Product Change Notification: MFOL-20RLLB058

CCB 7584 Final Notice: Qualification of UNIG as an additional final test location and scan and pack for selected MIC5350, MIC5332, MIC5331, and MIC2793 device families available in 8L UDFN (2x2x0.6mm) package.

CCB 7584
Pre and Post Change Summary
PCN #: MFOL-20RLLB058

Pre and Post Change Summary – T/R (Carrier Tape)

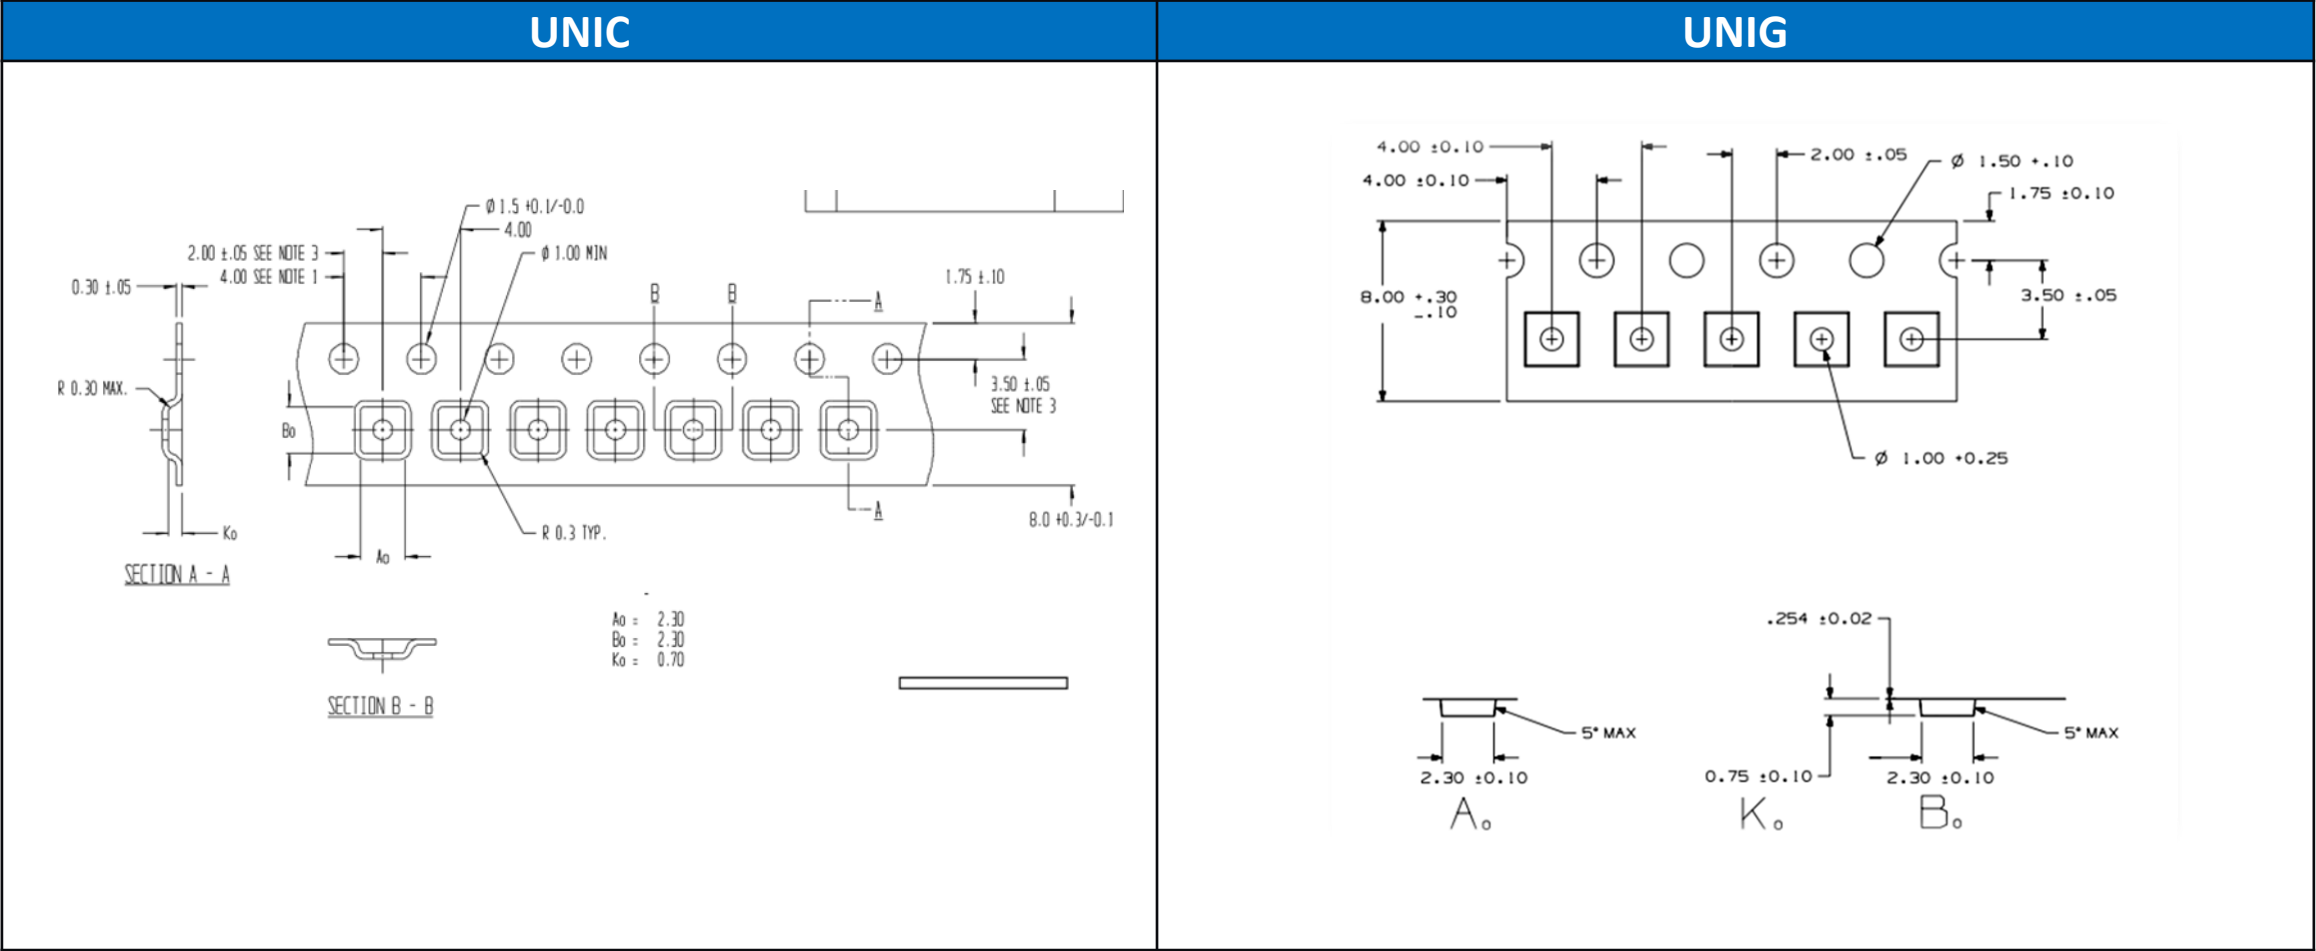
Plant	W (mm)	P (mm)	A0 (mm)	B0 (mm)	K0 (mm)	Thickness (mm)
UNIC	8	4	2.3	2.3	0.7	0.3
UNIG	8	4	2.3	2.3	0.75	0.254

Pre and Post Change Summary – T/R (Cover Tape)

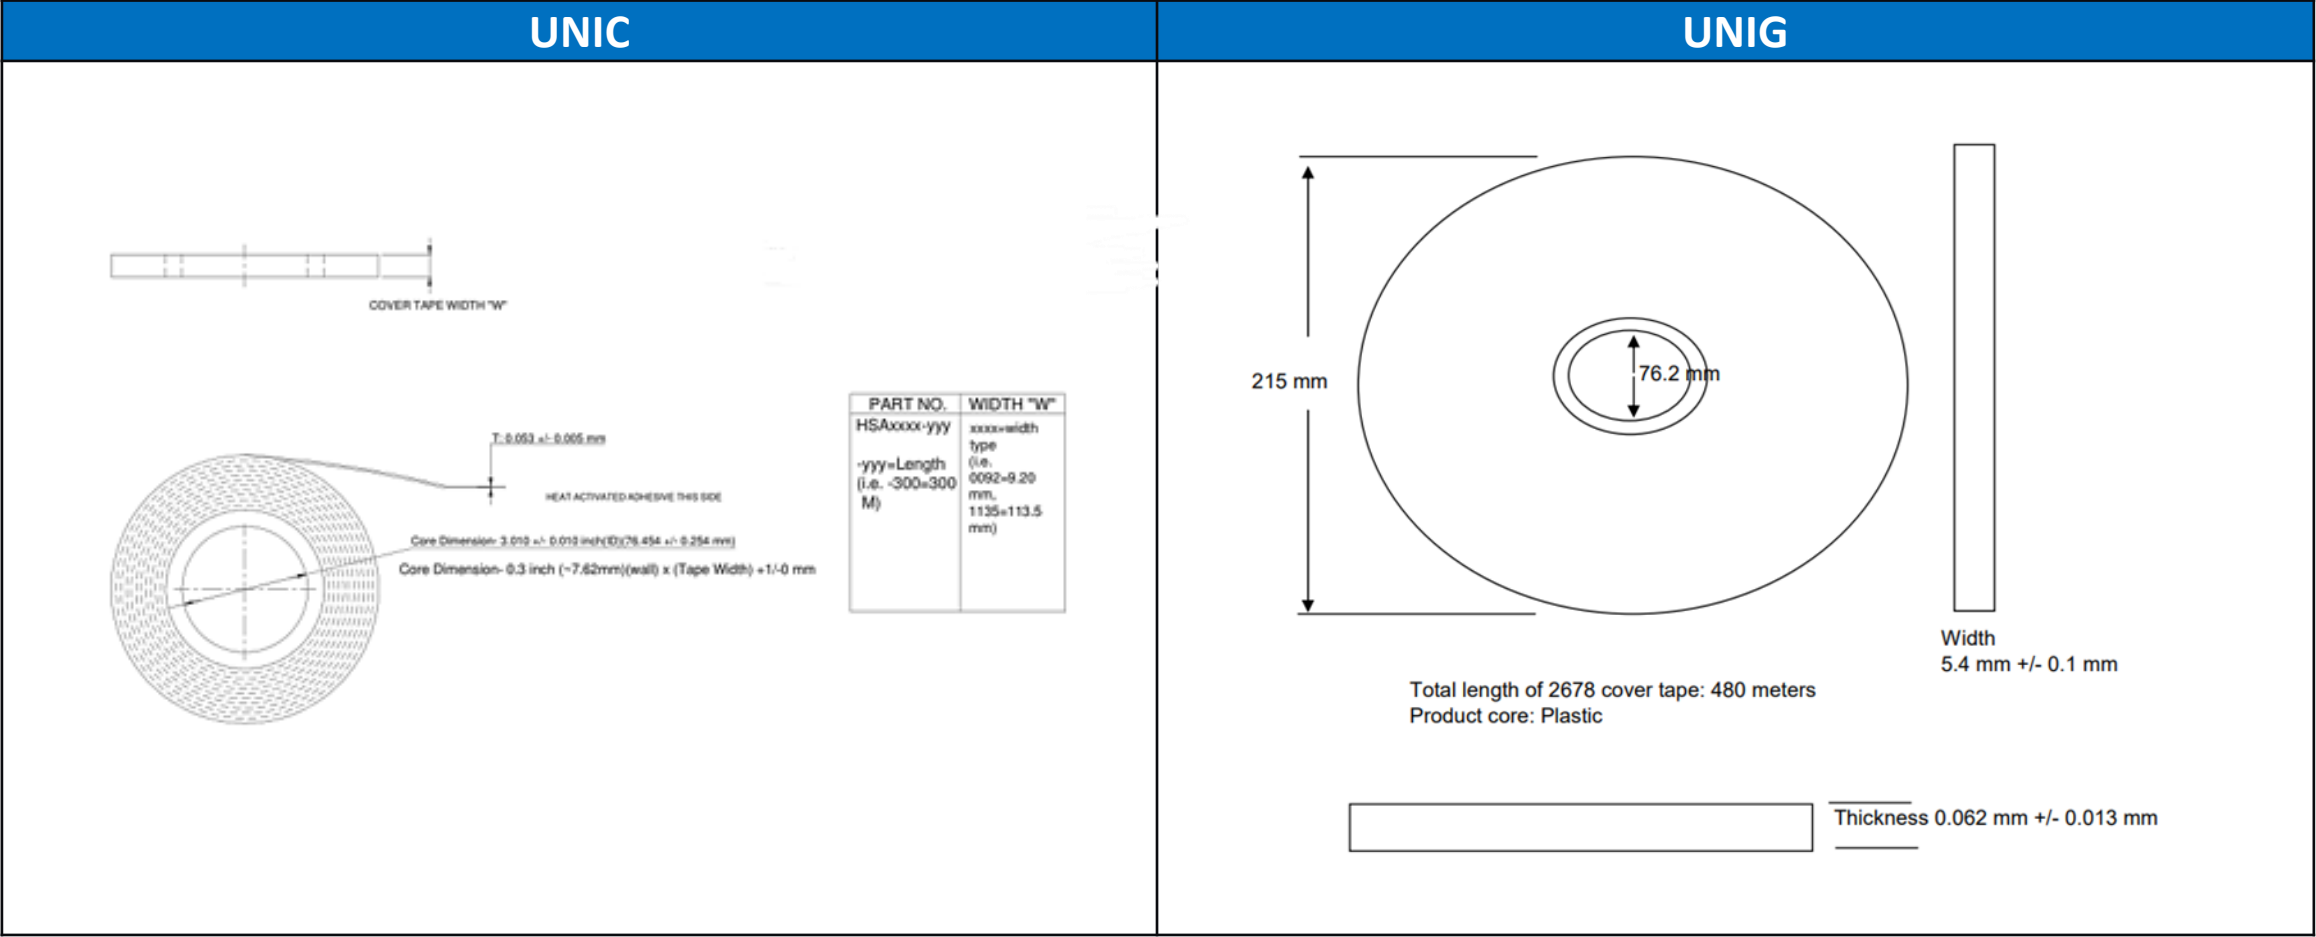
Plant	Width W (mm)	Thickness T (mm)	Color	Sealing Methodology
UNIC	5.4	0.053	Transparent	Heat sealing
UNIG	5.4	0.062	Transparent	Heat Sealing

Pre and Post Change Summary – T/R (Packing Method for MSL-1 Pack)

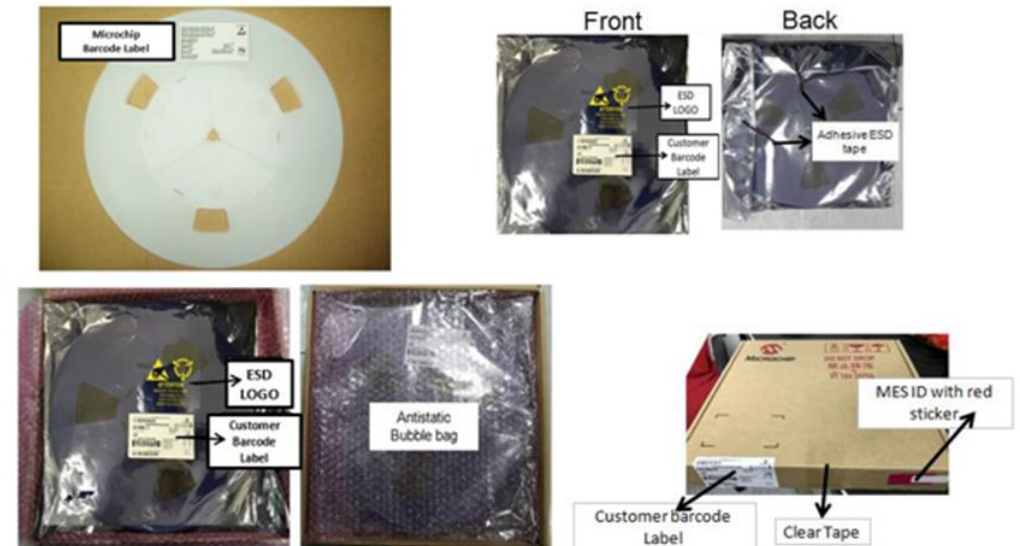
Inner box	
Drawing number	Dimension W x L x H (cm)
DWG-M02-009	35.6x34x5

Inner box	
Drawing number	Dimension W x L x H (cm)
DWG-M02-009	35.6x34x5
